COALPAC CONSOLIDATION PROJECT ENVIRONMENTAL ASSESSMENT

RESPONSE TO SUBMISSIONS

August 2012

COALPAC PTY LTD
Castlereagh Highway
CULLEN BULLEN NSW 2790

Figure 2
Indicative Locations for Monitors and Weather Stations

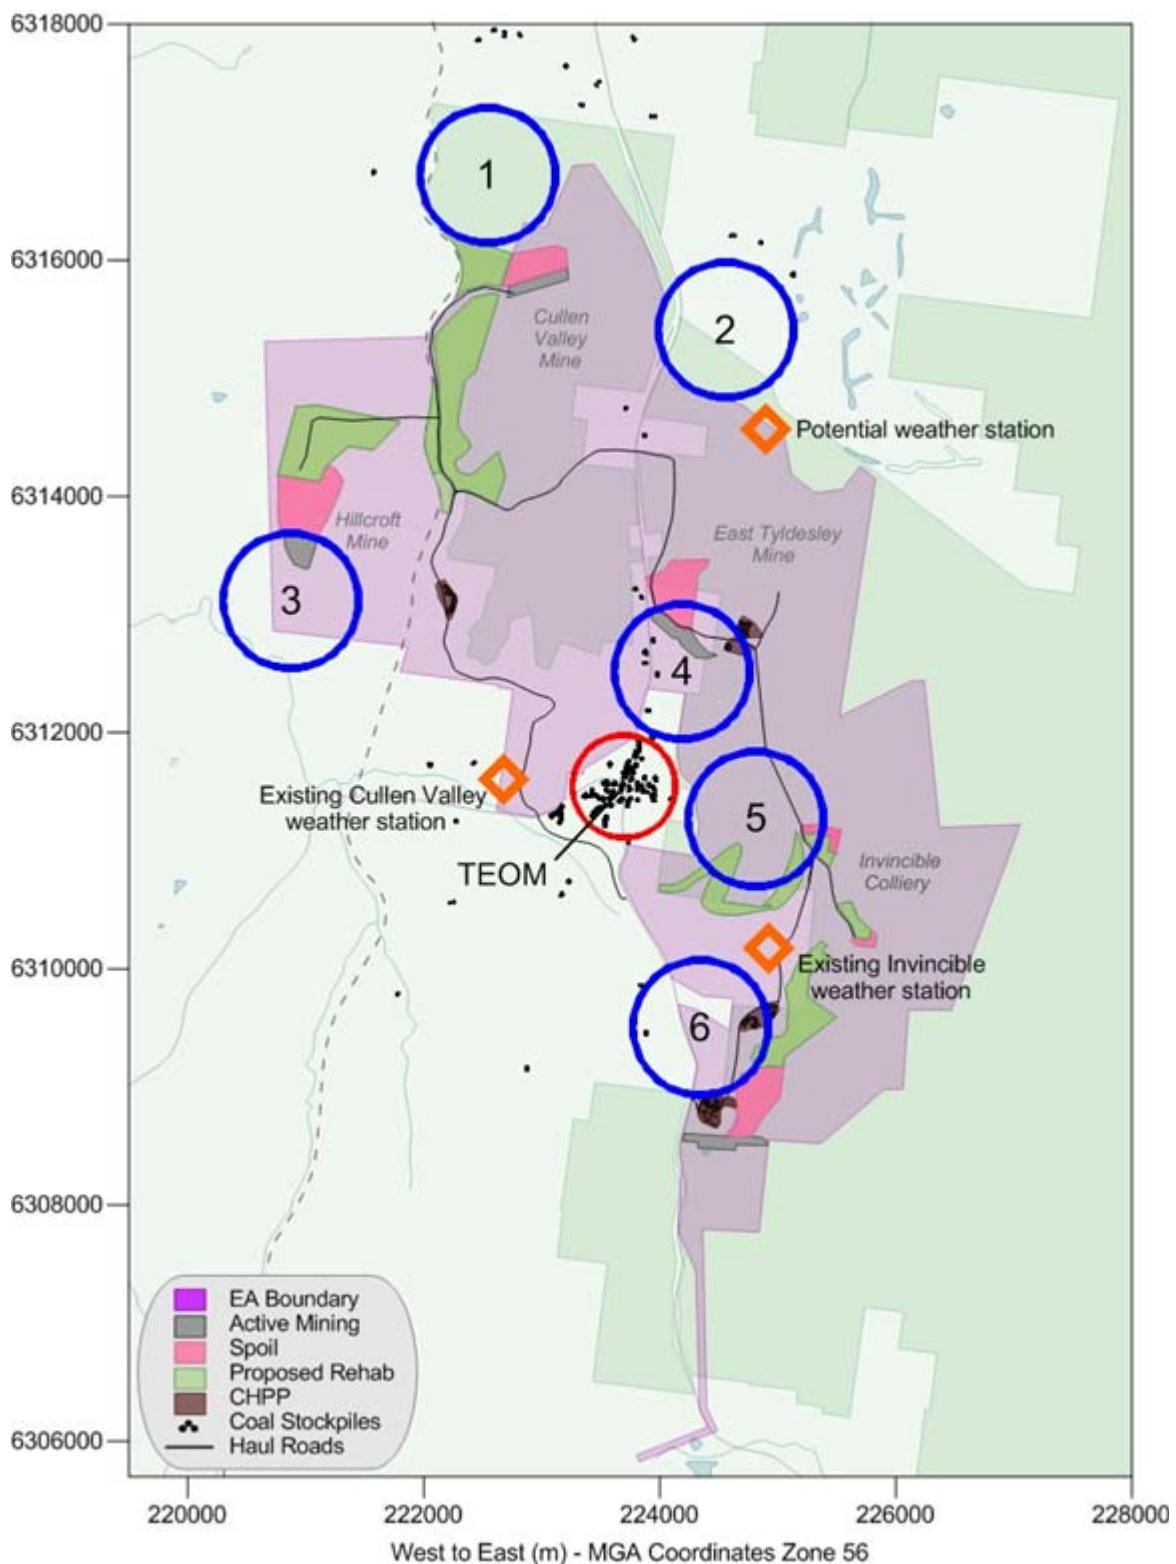
An array of approximately six boundary monitors would provide good upwind-downwind coverage for the proposed operations under predominant wind conditions.

Figure 2 provides an indication of initial areas that may be suitable for locating dust monitors. As the active areas move throughout the life of the Project some of these monitors may be moved to remain between operations and the nearest receptors.

A potential site for this additional station is shown in **Figure 2**. This additional information will be utilised for complaints management in addition to identifying the source of dust at particular times.

Figure
4

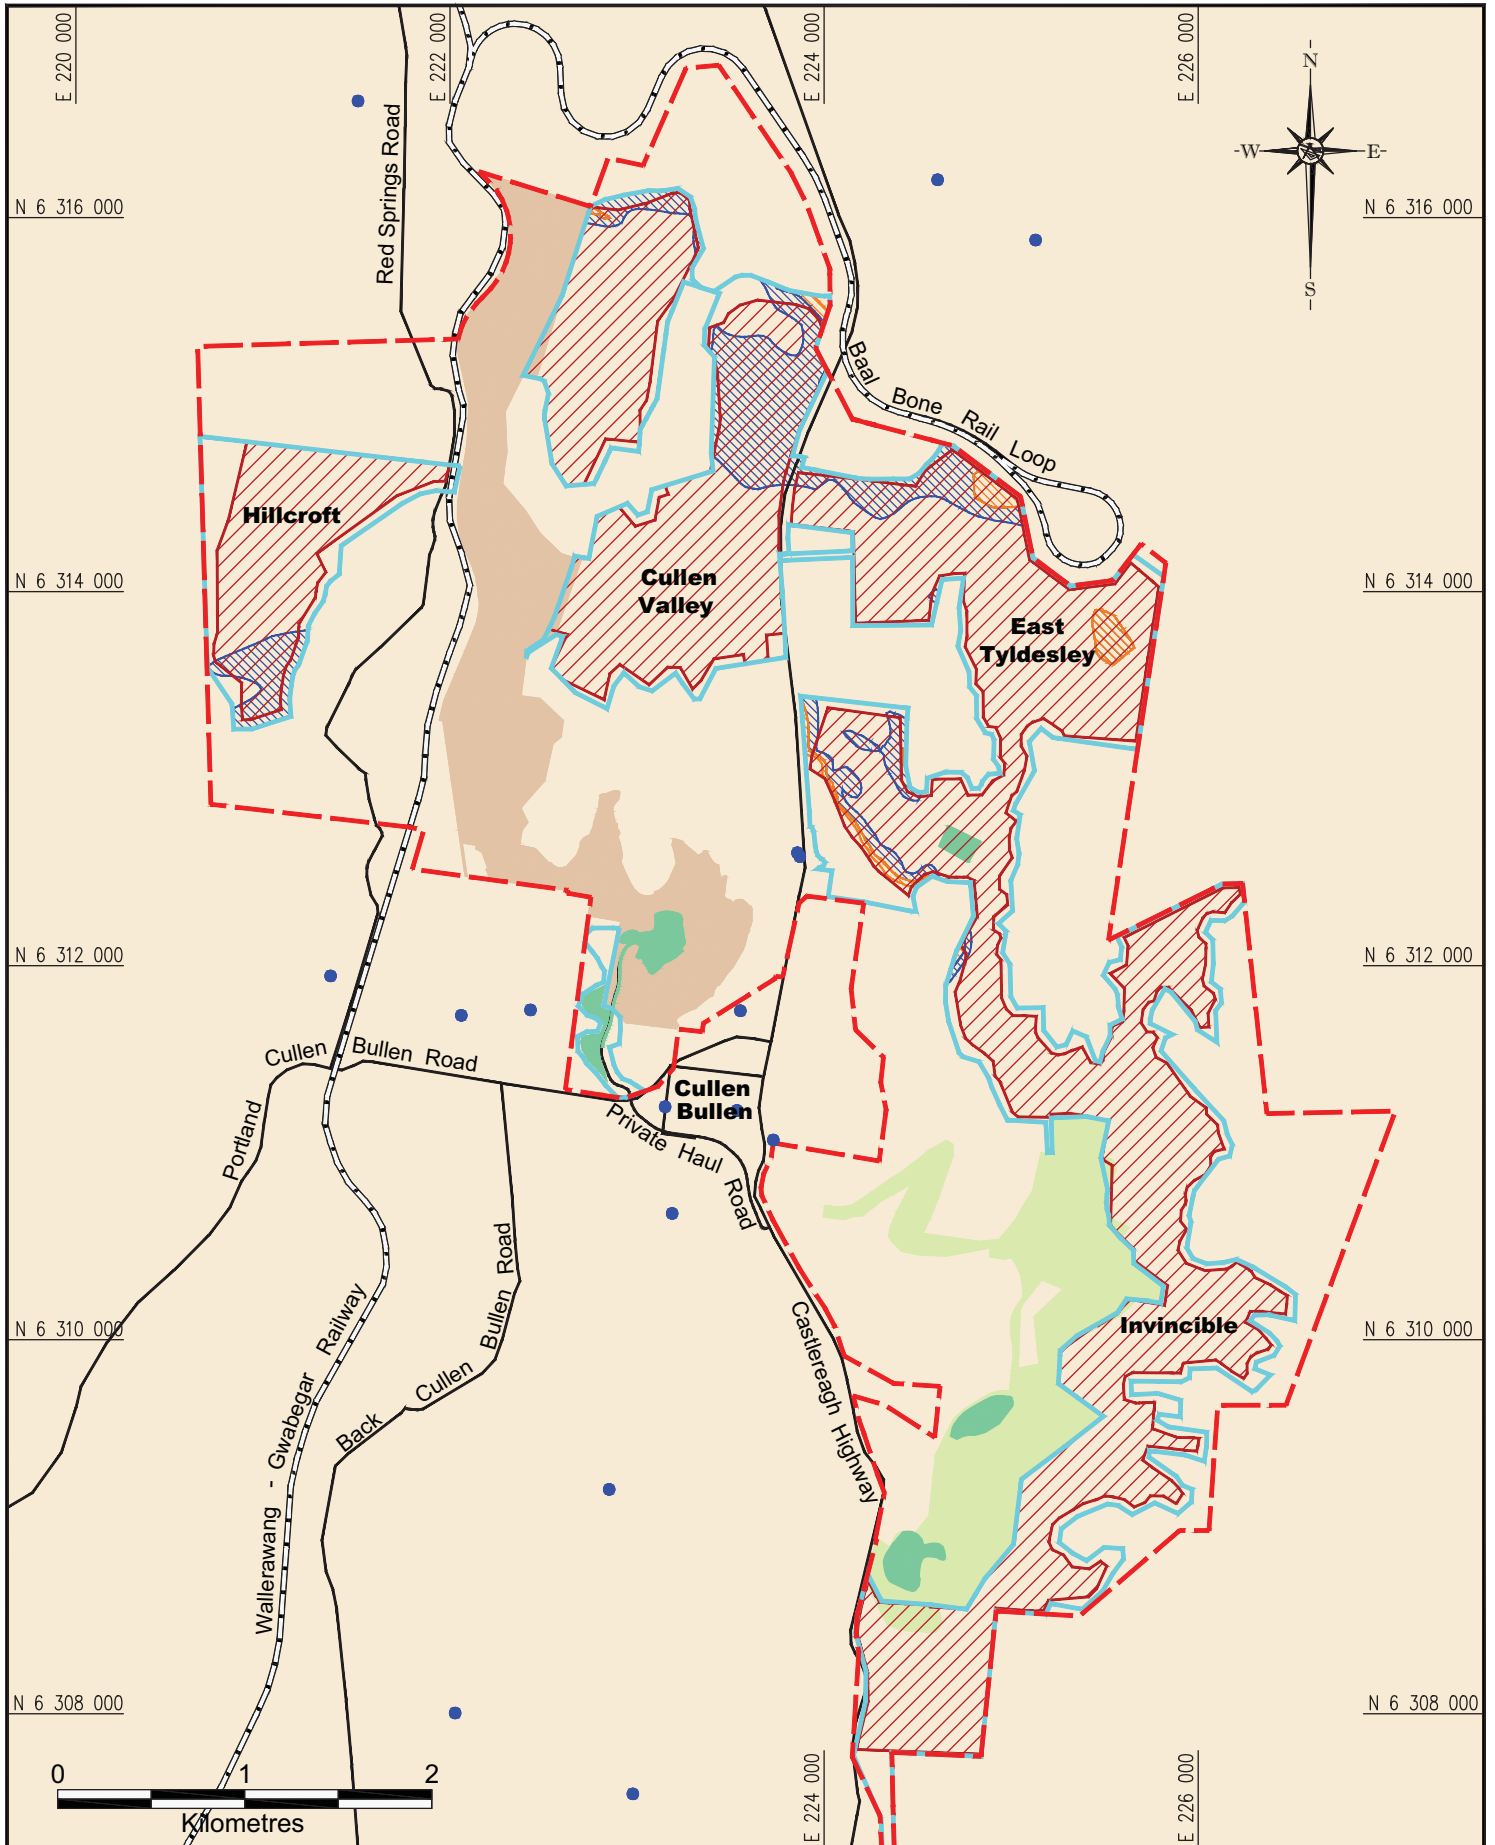
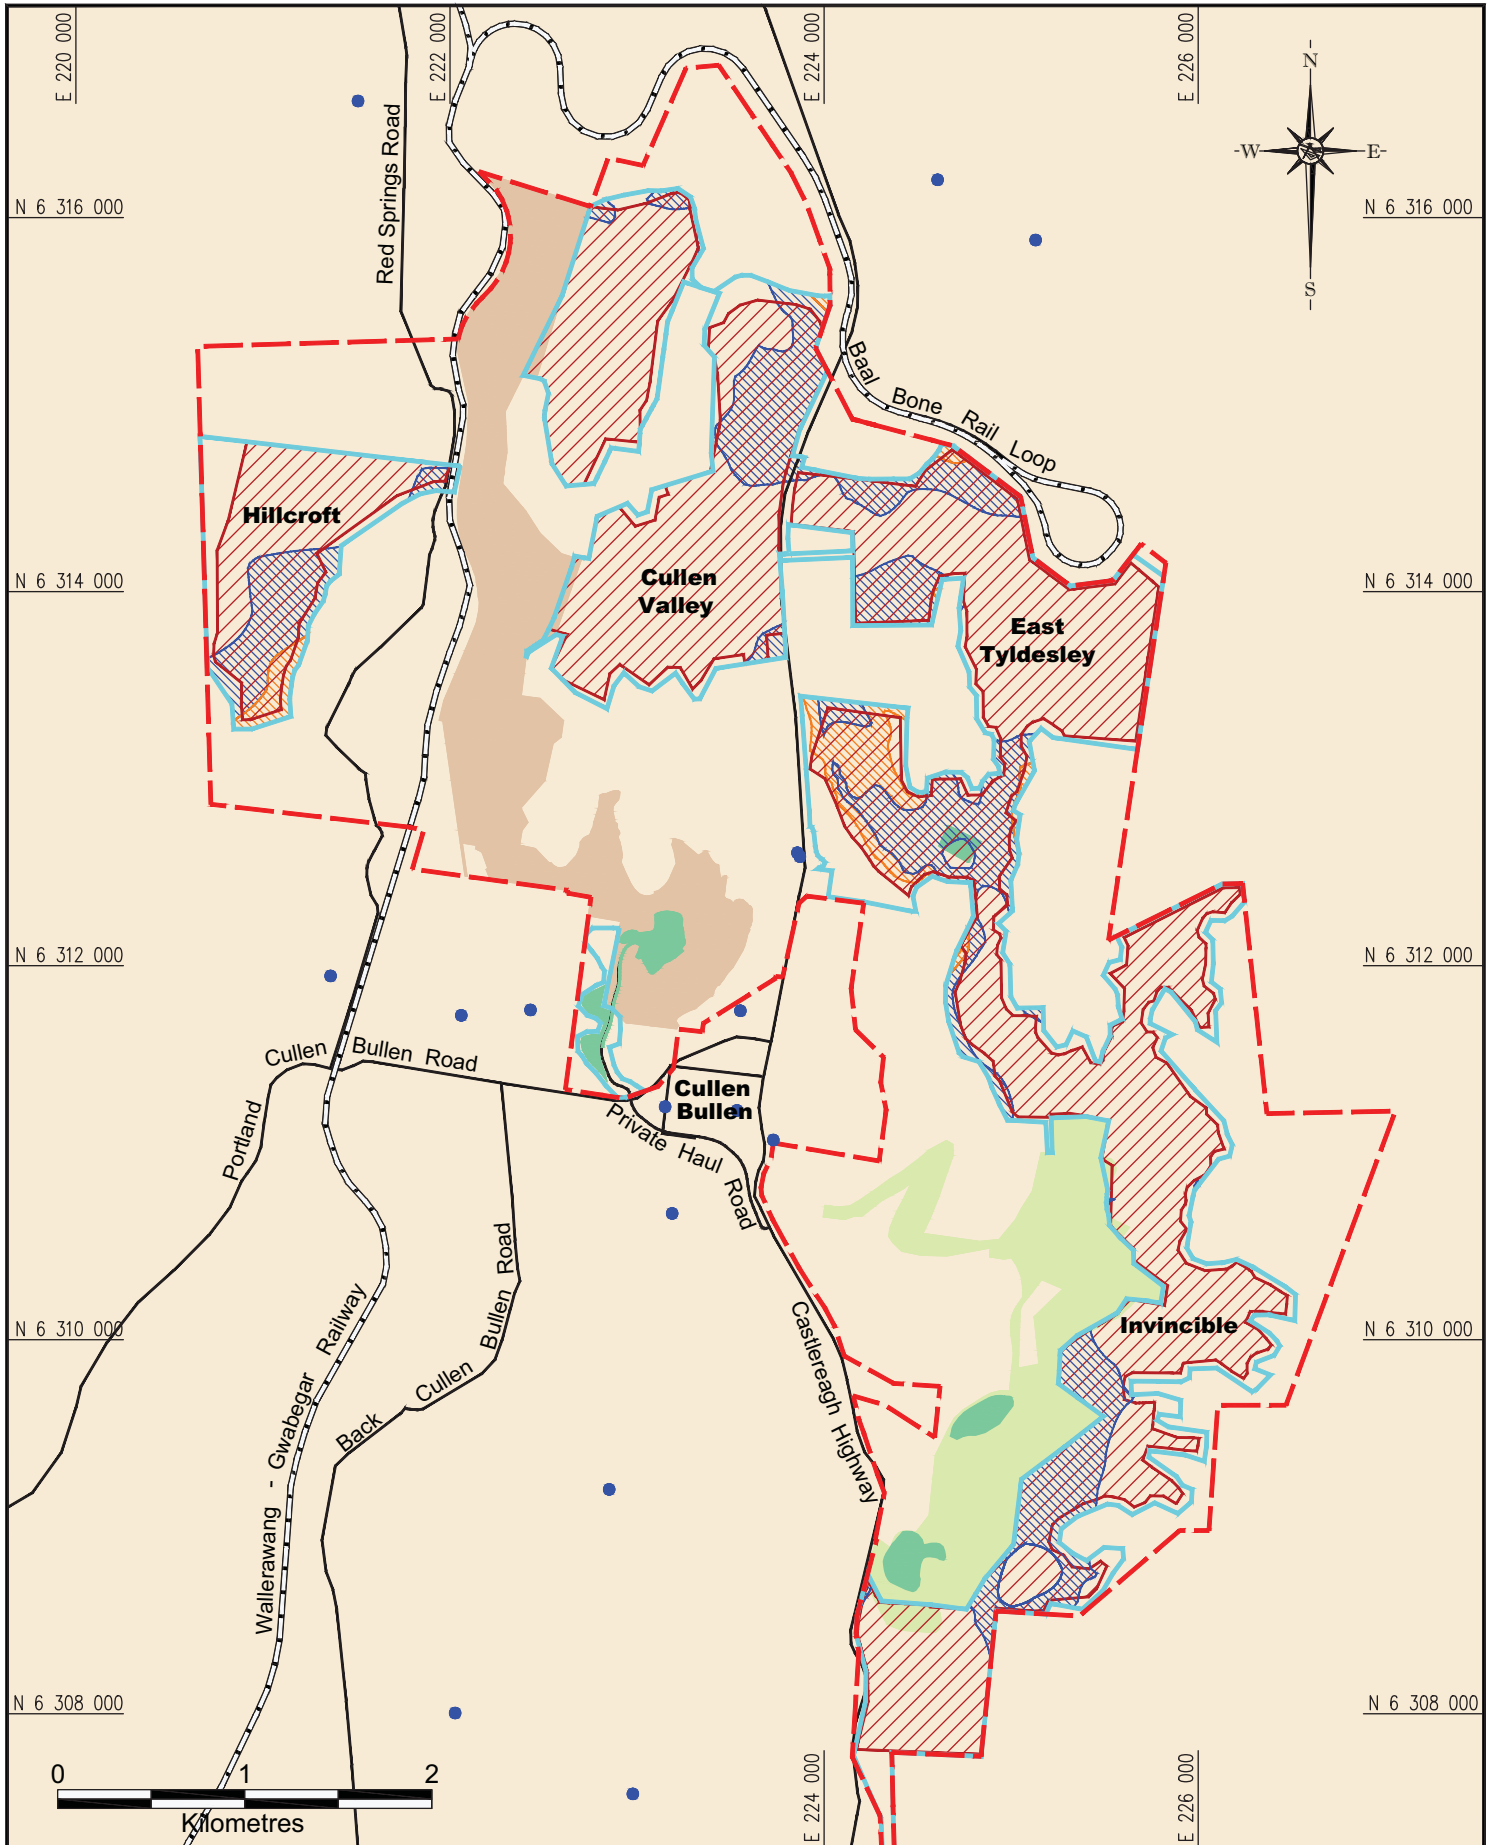
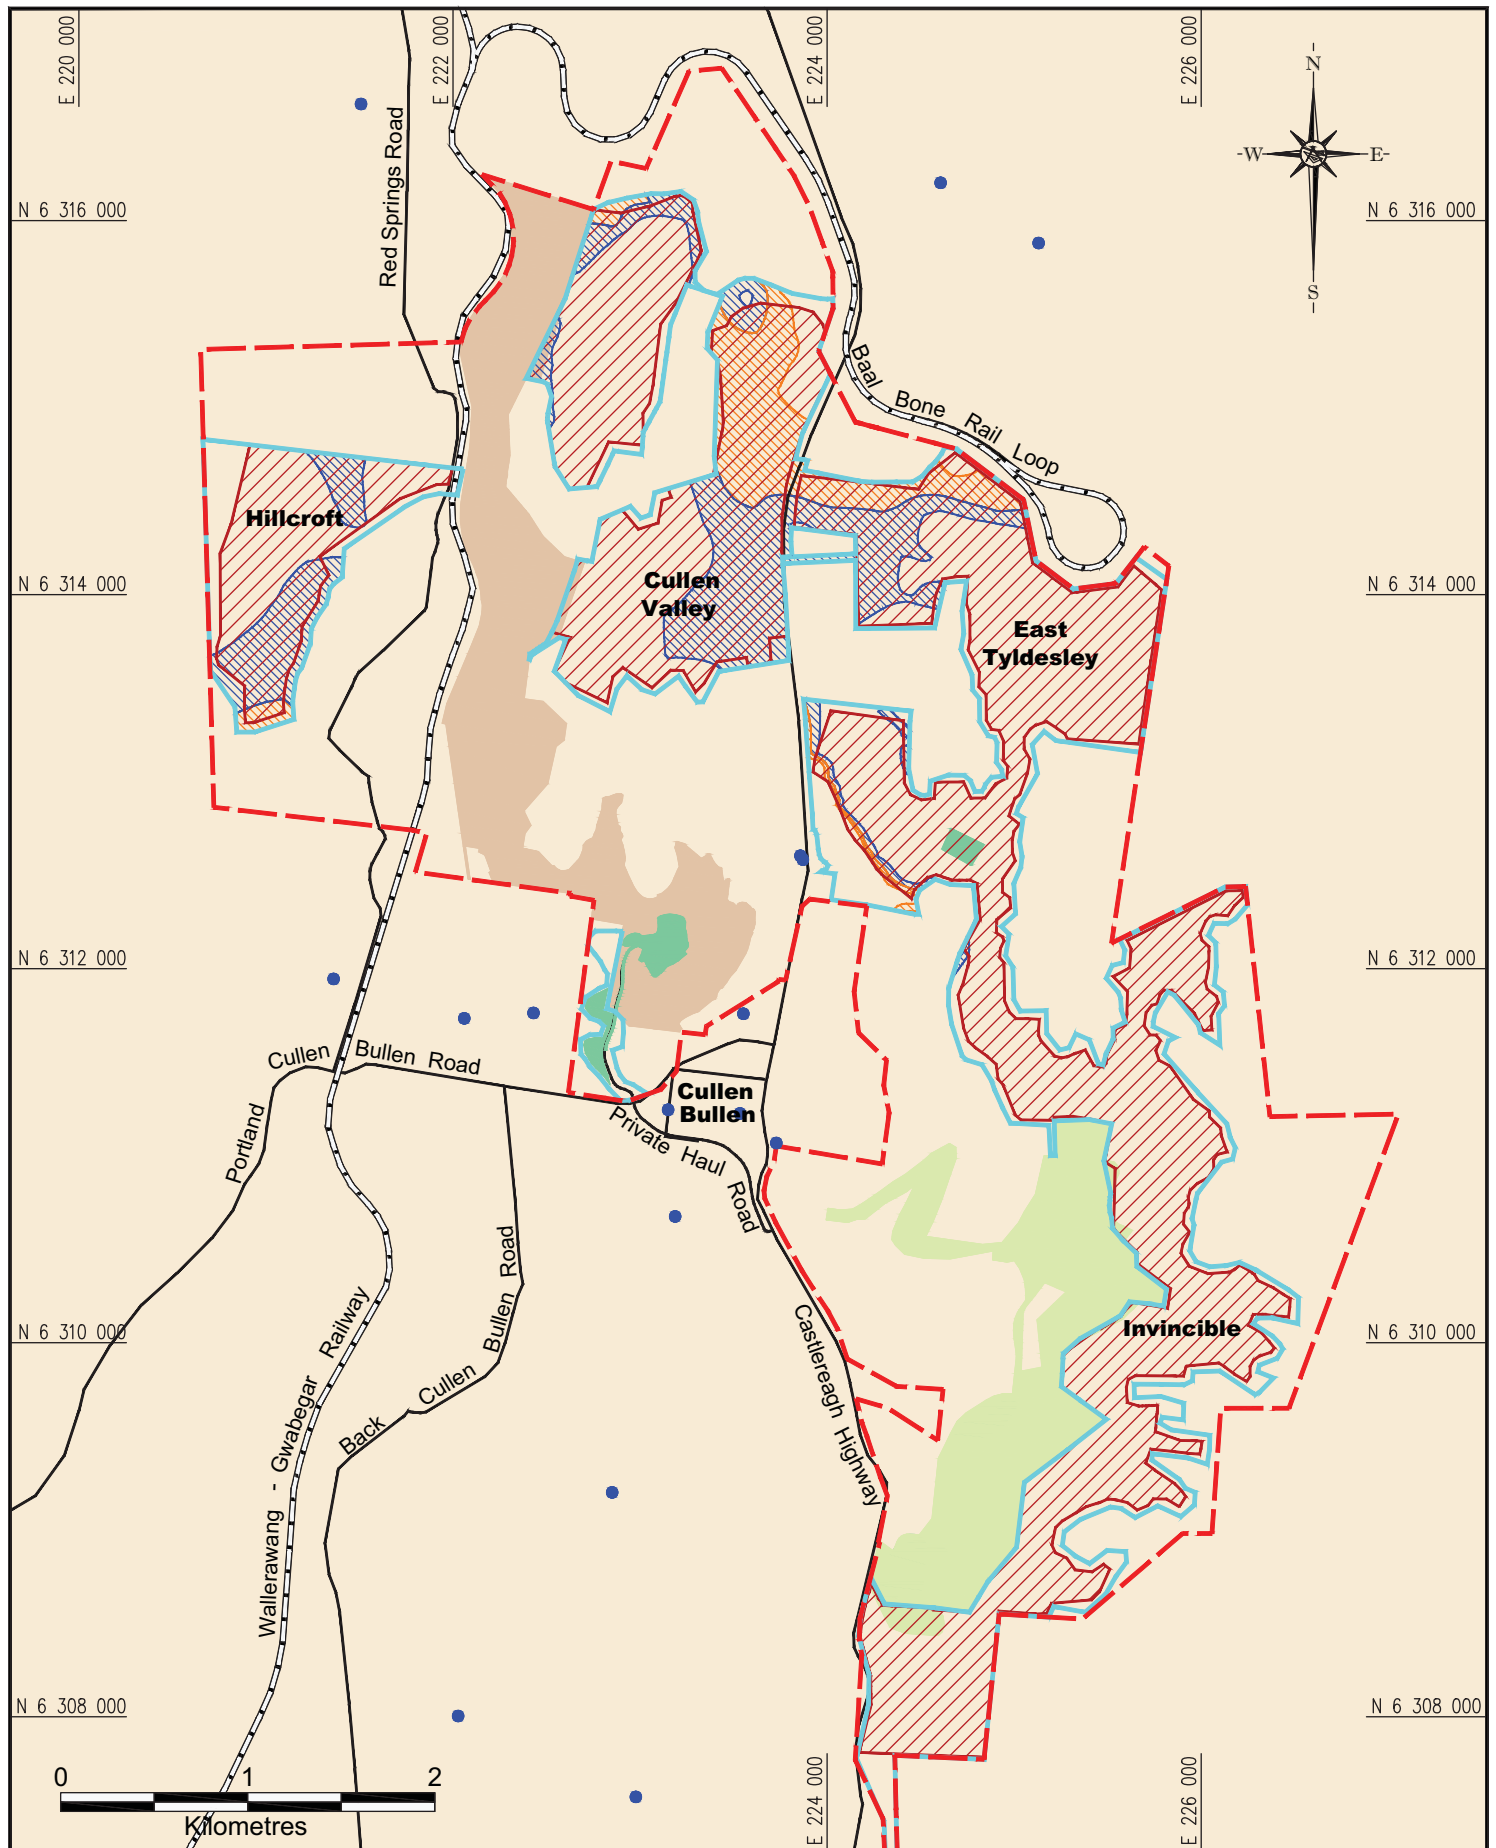
Areas within the Project Disturbance Boundary where management or modification of mining activities will be required under adverse meteorological scenarios are shown in **Figure 4** to **Figure 9**.

Figure 4 to **Figure 9** provide an outline of those areas under the five meteorological scenarios considered in the AIA where noise impacts at the nearest sensitive receptor locations are predicted to occur in the range of 35 – 40 dBA (Noise Management Zone 1) and in the range from 40 – 45 dBA (Noise Management Zone 2).
